BRE Client Report

Review of daylight and sunlight, Murphy's Yard

Prepared for: London Borough of Camden

Report Number: P122341-1000 Issue: 1

Figure 1. Plan by GIA showing the proposed development (in teal) and the nearest surrounding buildings. North is at the top of the plan.

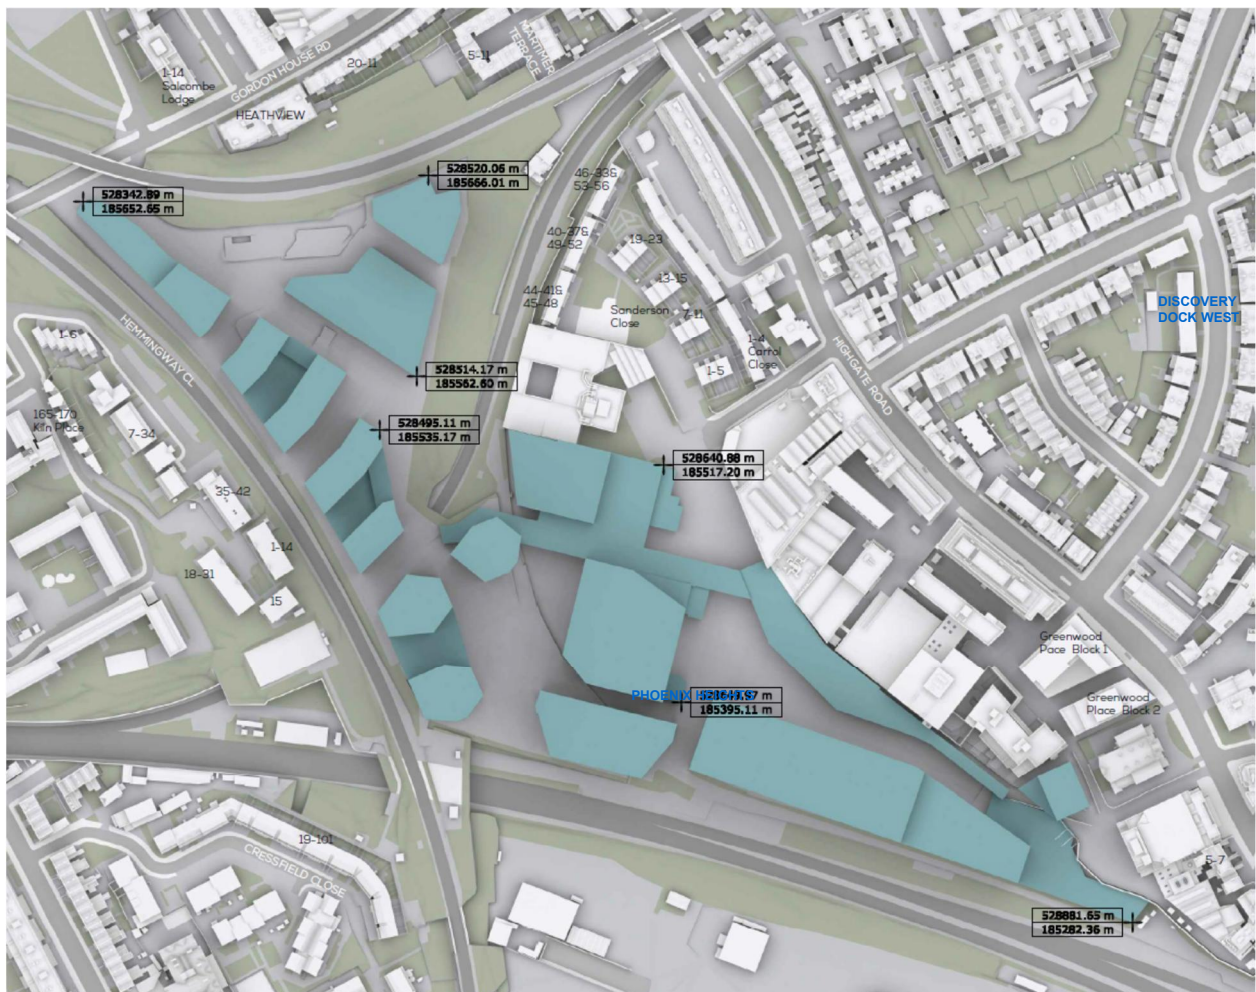
3.1.2 The site is currently occupied by low rise commercial buildings. To the north is the Gospel Oak to Barking railway line, with dwellings on Gordon House Road and Mortimer Terrace across it. To the north east are dwellings off Sanderson Close and Carrol Close. To the east is a largely commercial area off Highgate Road. To the south is the main Midland/Thameslink railway line from St Pancras to Bedford and Sheffield, with a commercial area, and dwellings in Cressfield Close, across it. To the west of the site is another railway line, the north London line from Gospel Oak to Stratford, with dwellings in Hemingway Close, Kiln Place and Meru Close across it.
